**W23a****ADDENDUM**

SUBJECT: ADDENDUM TO ITEM W23a, COASTAL COMMISSION PERMIT APPLICATION #5-07-334(La Forge) FOR THE COMMISSION MEETING OF May 7, 2008.

GEOTECHNICAL REVIEW MEMORANDUM

To: Liliana Roman, Coastal Program Analyst
From: Mark Johnsson, Staff Geologist
Re: CDP 5-07-334 (La Forge): Canyon edge delineation

FIGURE 3

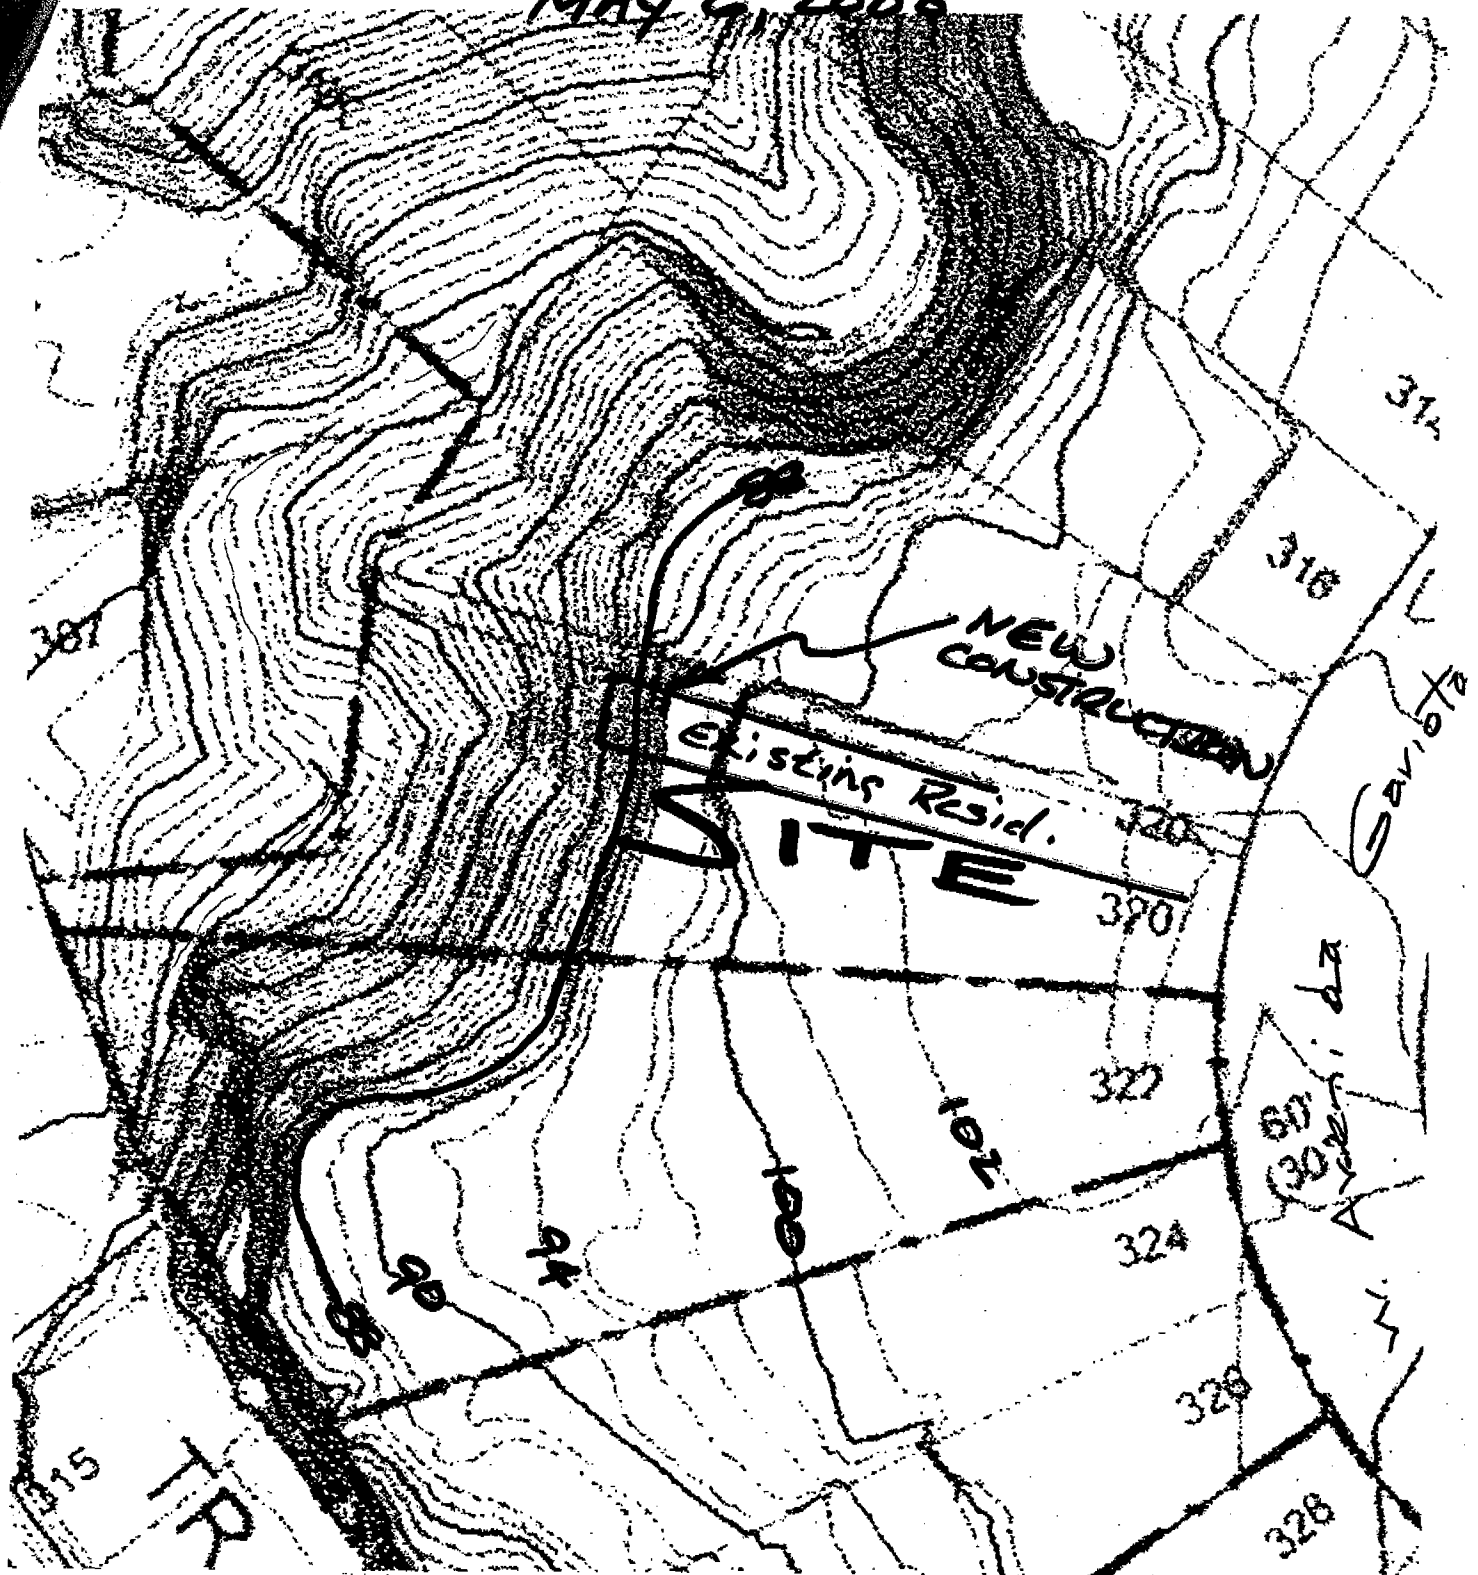
As shown on figure 3 of the geotechnical report, an 88-foot canyon edge may have been appropriate on the property to the south. On the property to the south tightening of the contours as the slope descends into the canyon does indeed occur at the 88-foot elevation. Application of this same methodology to the subject property would establish the break in slope at the 94-foot elevation where the contours tighten, not the 88-foot elevation. Lastly, a plot of the 88-foot contour on the geotechnical report topographic maps shows the 88-foot contour is 6 feet below where the contours tighten in spacing at 94 feet.

Figure 3 of the aforementioned geotechnical report is a relatively small scale (1" = 50') topographic map of the site and adjacent areas. Mr. Armstrong points out, correctly, that there is a distinct break in slope indicated on this map at the 94-foot contour. Indeed there is a step-like feature east of that break in slope at the 102 foot contour. Given the definition of bluff edge in §13577 (h) (2) of the Commission's regulations, the 94-foot, or arguably the top of the step-like feature as high as the 102 foot contour, could be interpreted as the canyon edge.

There exists, however, more detailed topographic data prepared by a survey of the site itself and appearing in Figure 5 and 6 of the aforementioned geotechnical report at a scale of 1" = 20'. These data show no step-like feature and, in the line of the cross section, show the slope leading toward the canyon bluff face to increase in steepness very gradually. The sharpest break in slope is near the 88 foot contour. Again, per the definition of bluff edge in the Commission's regulations it could be argued that the top of the bluff is "rounded away from the face of the cliff as a result of erosional processes related to the presence of the steep cliff face" below and that in order for the "bluff line or edge [to] be defined as that point nearest the cliff beyond which the downward gradient of the surface increases more or less continuously until it reaches the general gradient of the cliff," a higher point should be chosen as the bluff edge. During my site visit, it was apparent to me that an unequivocal justification of any such higher point would be difficult due to the very gradual and continuous increase in slope near the canyon edge and to the amount of landform alteration that had coincided with the previous development of the parcel. Accordingly, I chose to accept the applicant's interpretation of the bluff edge as at approximately the 88 foot contour.

Accordingly, interpreting the best available data and considering the effects of local landform alteration, I feel that the best interpretation of statute places the top of canyon edge in the general area of the 88 foot contour as indicated in figure 5 of the aforementioned geotechnical report.
